SOUTH FACADE ELEVATIONS

PROPOSED REVISION

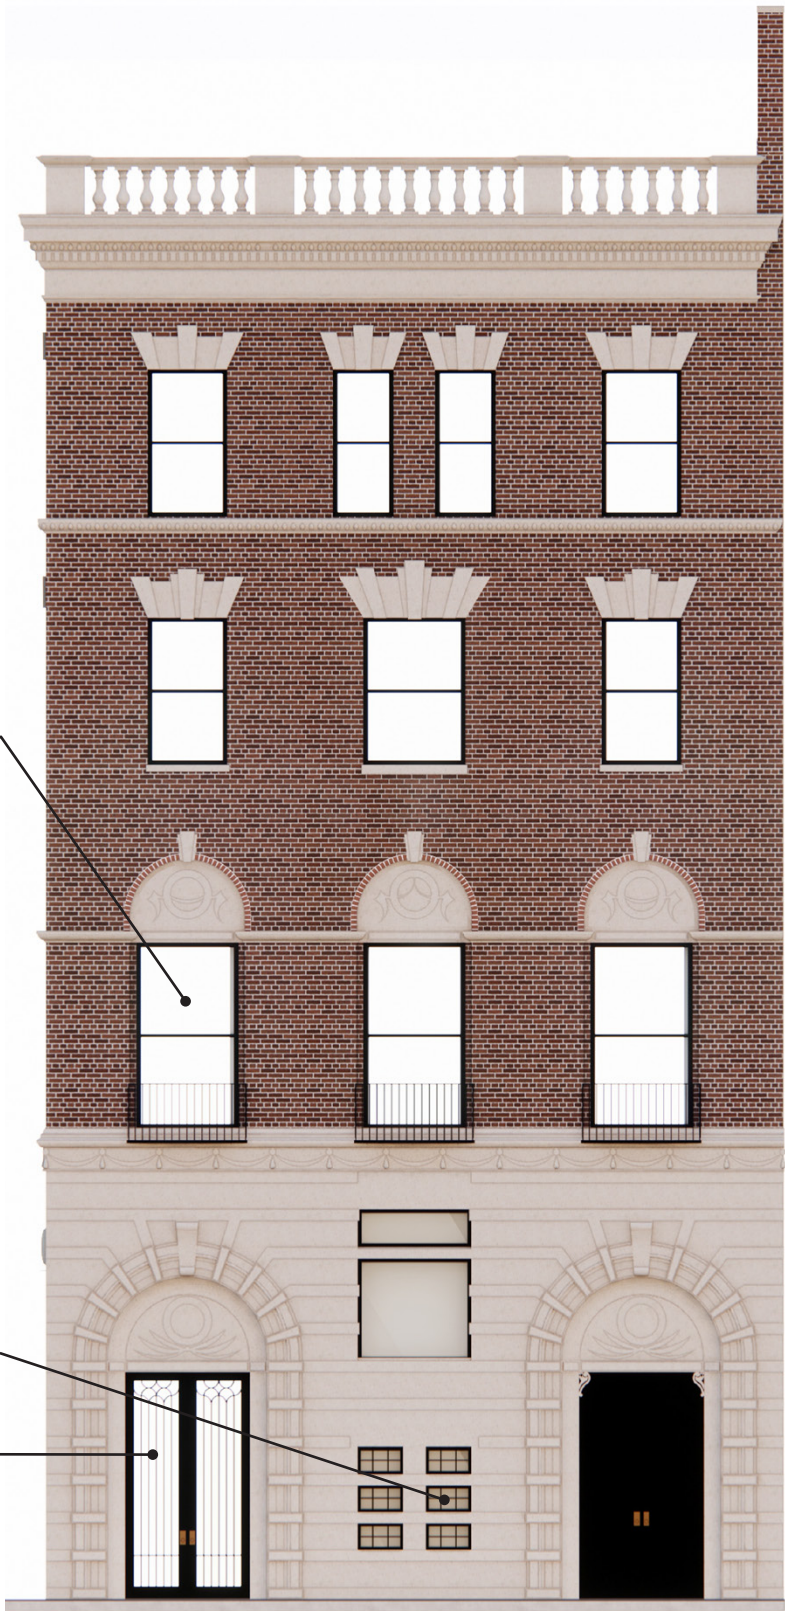
Propose to replace the existing French doors at the 2nd floor balconies with new French doors

Propose to remove the intermediate windows on the south facade

Revised entrance door design

REPLACING DOUBLE HUNG WINDOWS ON THE 2ND FLOOR WITH FRENCH DOORS - WEST FACADE
